The Alaskan Way Viaduct & Seawall Replacement Project

Retrofit of the Alaskan Way Viaduct: What WSDOT Learned December 2006

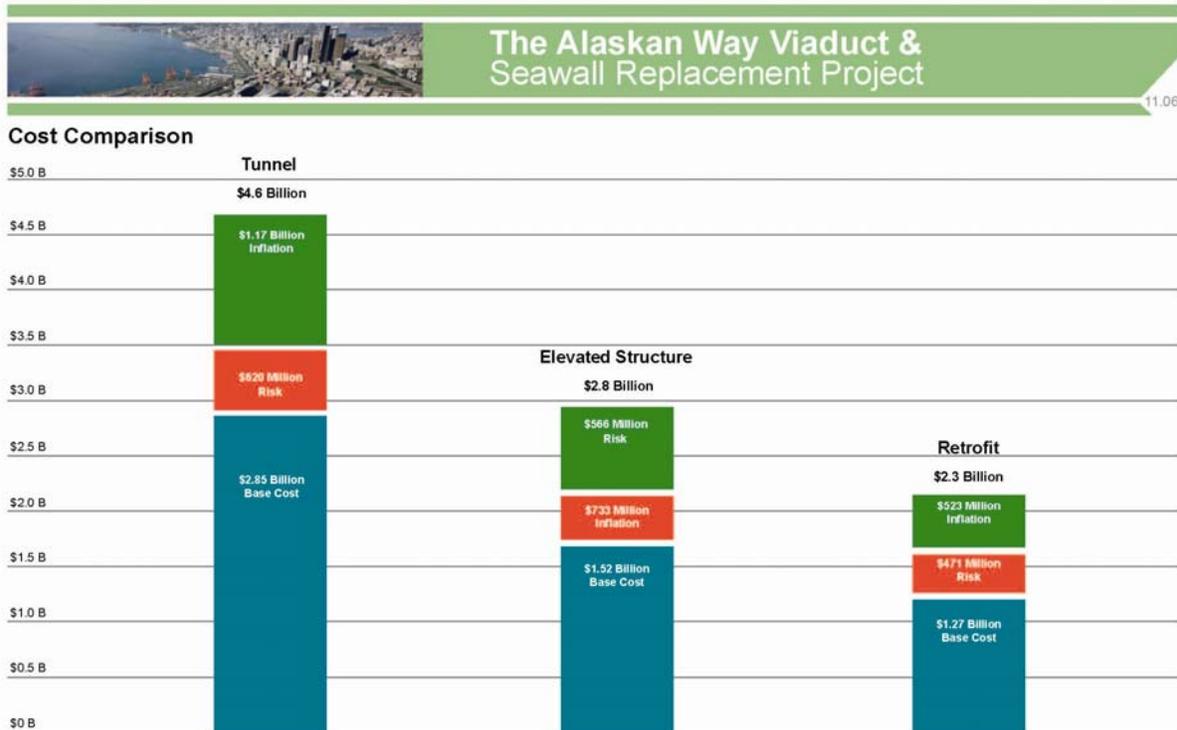
Additional improvements needed to the Viaduct Preservation Group's retrofit proposal, in order to meet an accepted standard of seismic risk are:

- The footings of the viaduct require retrofit.
- The lower floor beam / column joints need to be strengthened.
- The joints between the columns and upper floor beams need to be replaced.
